AMENDMENT GEOTECHNICAL REPORT

State Route 112: US 41A/Clarksville Pike From State Route 12 (Ashland City Highway) To Near State Route 155 (Briley Parkway) Project No. 19046-1214-14 PIN No. 103764.00 Davidson County

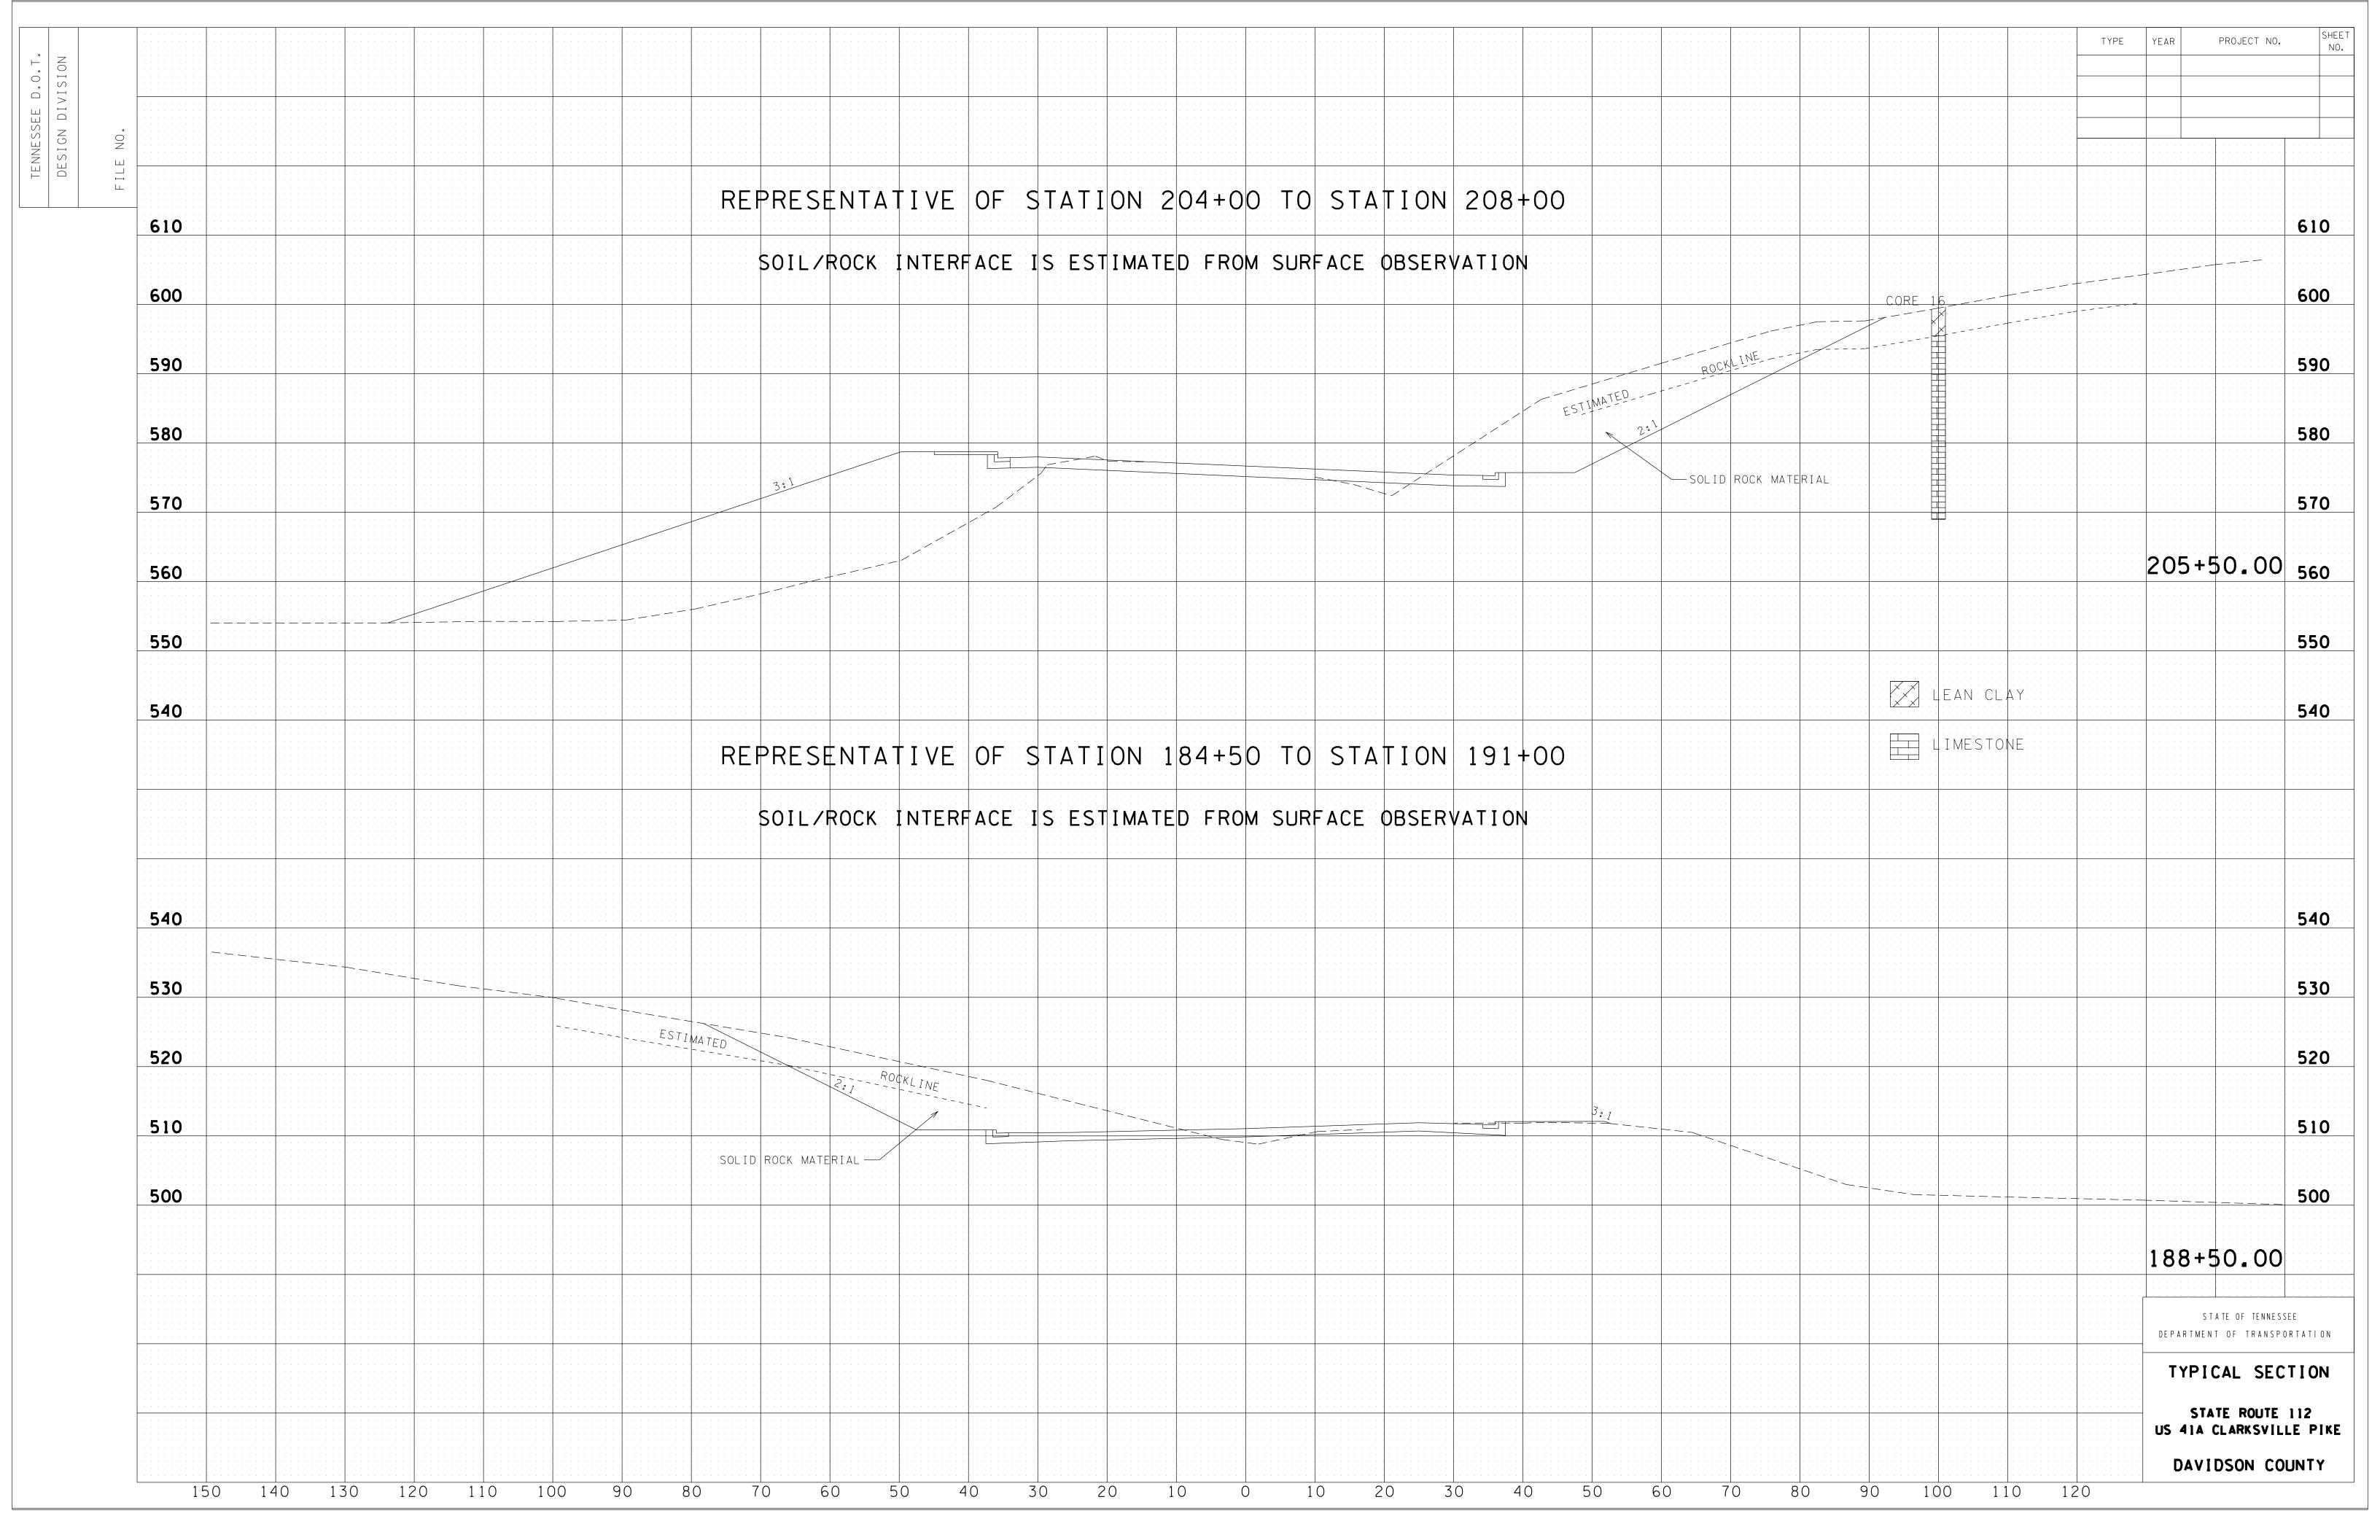
Rock cut slopes are proposed to the left of centerline from Station 115+50 to Station 118+00. As stated in the original 2010 report, based on the subsurface exploration and visual observations, the estimated soil rock interface is relatively shallow. It is recommended that the rock and overlying soil in this area be cut back and placed on a 2:1 slope. Refer to the Typical Section, "REPRESENTATIVE OF STATION 115+50 TO STATION 118+00", included with this report for further details.

Rock cut slopes are proposed to the right of centerline from Station 124+00 to Station 129+00. As stated in the original 2010 report, based on the subsurface exploration and visual observations, the estimated soil rock interface is relatively shallow. It is recommended that the rock and overlying soil in this area be cut back and placed on a 2:1 slope. Refer to the Typical Section, "REPRESENTATIVE OF STATION 124+00 TO STATION 129+00", included with this report for further details.

Rock cut slopes are proposed to the left of centerline from Station 184+50 to Station 191+00. As stated in the original 2010 report, based on the subsurface exploration and visual observations, the estimated soil rock interface is relatively shallow. It is recommended that the rock and overlying soil in this area be cut back and placed on a 2:1 slope. Refer to the Typical Section, "REPRESENTATIVE OF STATION 184+50 TO STATION 191+00", included with this report for further details.

Rock cut slopes are proposed to the right of centerline from Station 204+00 to Station 208+00. As stated in the original 2010 report, based on the subsurface exploration and visual observations, the estimated soil rock interface is relatively shallow. It is recommended that the rock and overlying soil in this area be cut back and placed on a 2:1 slope. Refer to the Typical Section, "REPRESENTATIVE OF STATION 204+00 TO STATION 208+00", included with this report for further details.
